ACME (Aerospace Contamination Museum of Education) Comments - Deep Borehole FSP Addendum December 1, 2011

United States Environmental Protection Agency (EPA) Region IX (Via Electronic Mail)

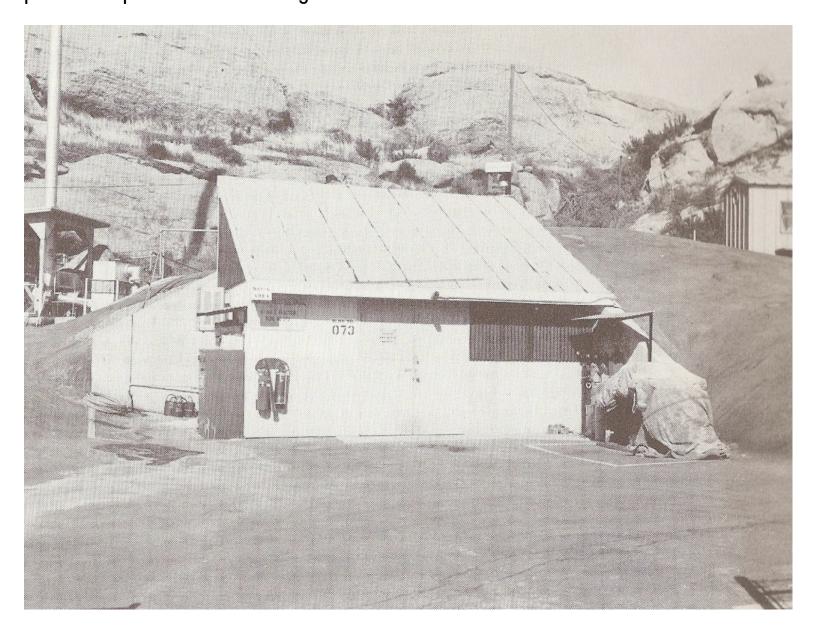
Additional boreholes are needed in the Sodium Reactor Experiment (SRE) area near your proposed location 7 (Figure 2) as that was the location of the reactor itself. There needs to be additional boreholes to the south of location 8 (Figure) as this was the Fuel Rod Storage area with a Hot Lab in the basement that should validate the need to investigate at greater depth.

Additional boreholes are needed within the entire footprint of the KEWB (Figure 2) and a few feet from the outer footprint due to the fact that the reactor and it's building were decommissioned and disposed of in it's own below grade structure and could have potential impacts to the soil and groundwater.
